WEBSTER UNIVERSITY ISB	
PROJECT NAME	
8274 BIG BEND BLVD	
ADDRESS	
NUMBER	
WEBSTER UNIVERSITY	
OWNER	
CANNON DESIGN	
ARCHITECT / ENGINEER	
DEVIN D GATES	
SUBMITTED BY	
123553-001 REV 2	
CONTRACTOR / CM SUBMITTAL NO.	CANNON DESIGN SUBMITTAL NO.
	123553
DRAWING / DETAIL REFERENCE	SPECIFICATION SECTION / PARAGRAPH
MANUFACTURER / SUPPLIER	ITEM / PRODUCT ID
REQUIRED DATE	PRIORITY
	CRITICAL

DATE: 1/25/2017
JOB: 04437A, B, C, D
RE: Webster University
Webster Groves, MO

COPIES	DATE	NO.	DESCRIPTION
1	1/25/17	04437ARI -E2 and 04337BRI -E4	Rough-In & Elevation Shop Drawings
1	1/25/17	04437DETAILS1 & 04437DETAILS2	Cabinet Sections
1	1/25/17	04437OHSC	OHSC detail/quantities Sheet
1	1/25/17	Set	Project Data Document

9676GRAPH

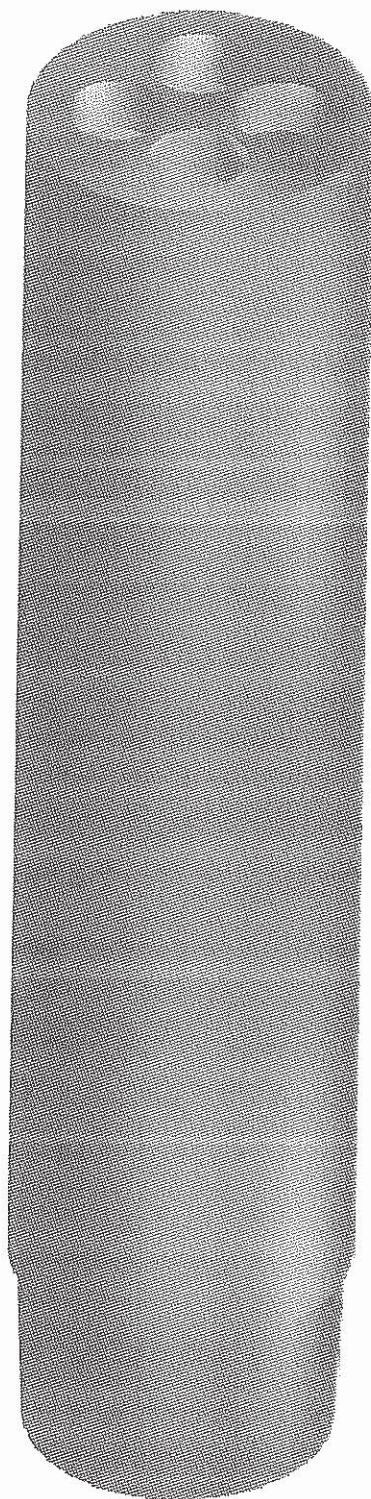
COORDINATE WITH
PLUMBING DOCUMENTS.

PLUMBING TO REVIEW

9680GRAPH

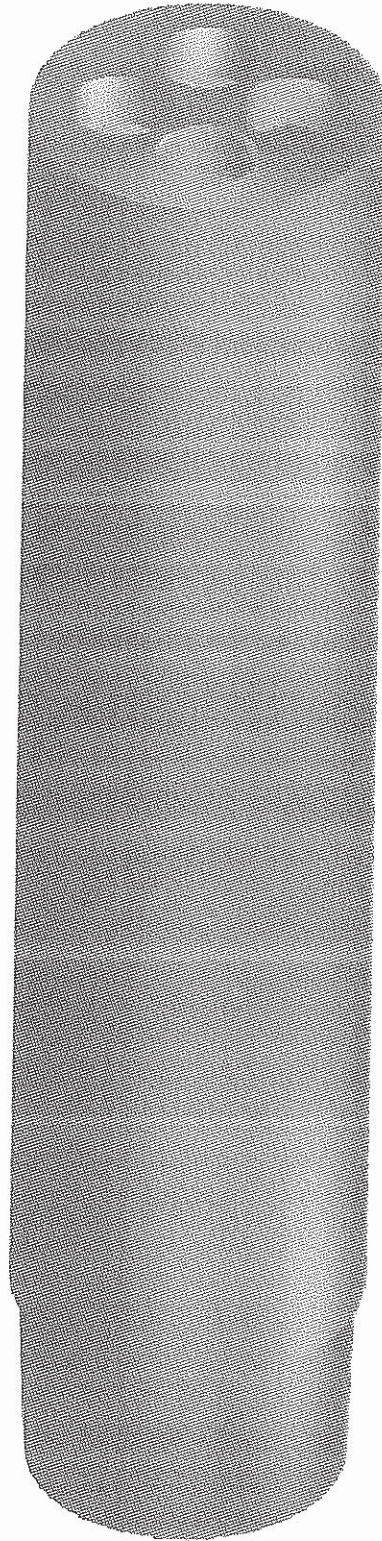
COORDINATE WITH
PLUMBING DOCUMENTS.

PLUMBING TO REVIEW
